**PCN#20200630000.1
New Tray for Select Devices
Final Change Notification**

PCN Number:	20200630000.1	PCN Date:	July 30, 2020
Title:	New Tray for Select Devices		
Customer Contact:	PCN Manager	Dept:	Quality Services
Proposed 1st Ship Date:	Oct. 30, 2020		
Change Type:			
<input type="checkbox"/>	Assembly Site	<input type="checkbox"/>	Design
<input type="checkbox"/>	Assembly Process	<input type="checkbox"/>	Data Sheet
<input type="checkbox"/>	Assembly Materials	<input type="checkbox"/>	Part number change
<input type="checkbox"/>	Mechanical Specification	<input type="checkbox"/>	Test Site
<input checked="" type="checkbox"/>	Packing/Shipping/Labeling	<input type="checkbox"/>	Test Process
		<input type="checkbox"/>	Wafer Bump Site
		<input type="checkbox"/>	Wafer Bump Material
		<input type="checkbox"/>	Wafer Bump Process
		<input type="checkbox"/>	Wafer Fab Site
		<input type="checkbox"/>	Wafer Fab Materials
		<input type="checkbox"/>	Wafer Fab Process

Device Fit Analysis:

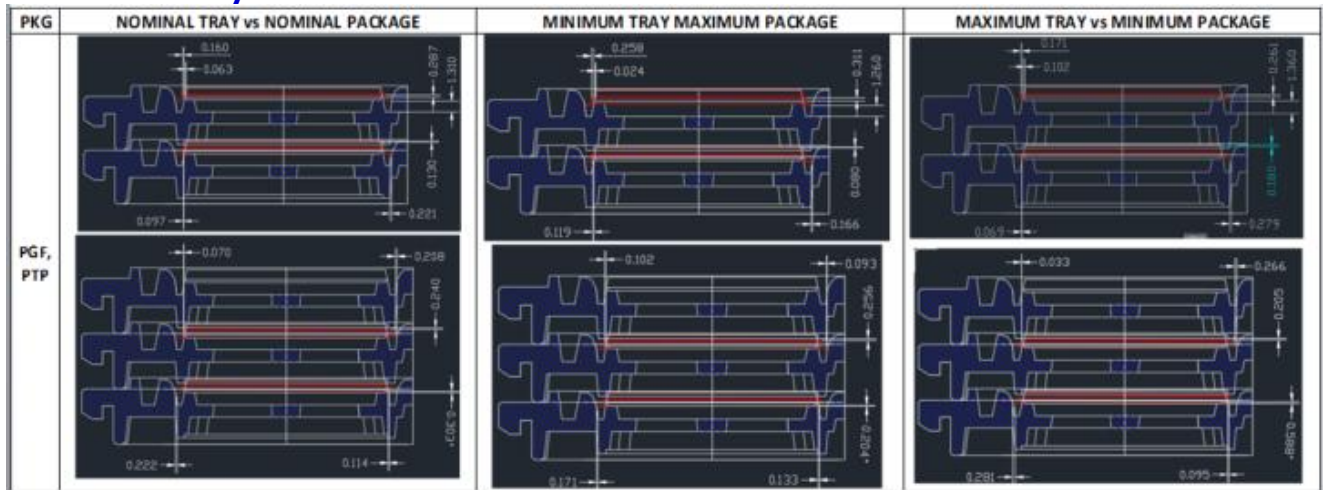
Texas Instruments is pleased to announce the qualification of a new tray for the devices listed below. A comparison summary of the tray differences as follows:

New tray offers improvement on tray warpage, chipping, stuck up caused by current tray
